US 67 CORRIDOR MASTER PLAN

APPENDIX U

**US 67 Corridor Master Plan
Corridor Master Plan Public Review Period – Comment Response Matrix**

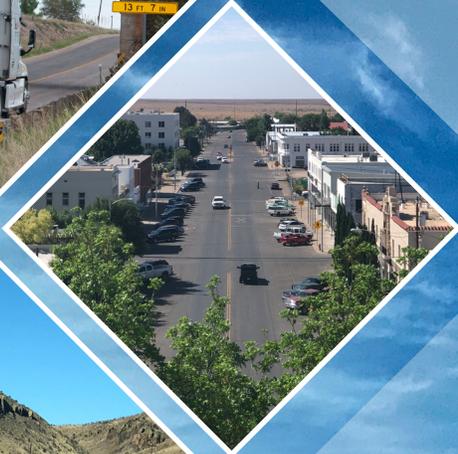
| Comment Number | Commenter Name | Date Received | Source | Comment | Response |
|--|----------------|-------------------|-------------------------|--|---|
| 3 | Gary Schatz | December 13, 2019 | Email Record | <p>I really like the GIS viewer. Funny that on my first click I find a possible typo: "shared use bath". Not sure that can be found in the RDM, but hey if others are good with it then I am too! ;-) (Screenshot [below])</p>  <p>Good to see PHBs, roundabouts and complete streets mentioned. Given that a number of the cyclists out there are long-distance riders, a cycle track might be a better choice than a shared use path.</p> <p>Regarding the ADTs in Alpine, are those bidirectional? Holland and Ave. E function as a one way couplet, but the counts are placed on Ave. E. Perhaps consider splitting the counts to show EB on Holland and WB on Ave. E.</p> <p>Speaking of Holland and Ave. E, they are auto-centric roads passing through a people-centric place. What is the desired operating speed the project hopes to achieve? What strategies are being considered to minimize the apparent mismatch of functionality? To what degree will "urban architecture" be part of the toolbox?</p> <p>Best regards, Gary</p> | <p>Thank you for your comment, the typo in the GIS viewer has been corrected.</p> <p>A cycle track in Alpine was considered early in the project phase but due to existing ROW constraints, the alternative was not carried forward for further evaluation. A Shared Use Path would provide the benefits providing space to pedestrian and cyclist traffic within the existing footprint of the roadway. The proposed alternative was also supported by the local population.</p> <p>The AADT locations in Alpine where US 67 is split shows the AADT for both directions combined, even if they're located on Ave E.</p> <p>The operating speed was not intended to change but the level of service was maintained or improved through the analysis years. However, the technical memo does discuss certain traffic calming methods which can be used by the City for future studies and projects. Chapter 6 is intended to be used as a toolbox by the communities for bicycle and pedestrian options to be incorporated throughout the city of Alpine, the recommendations are based on public input as well as feasibility.</p> |
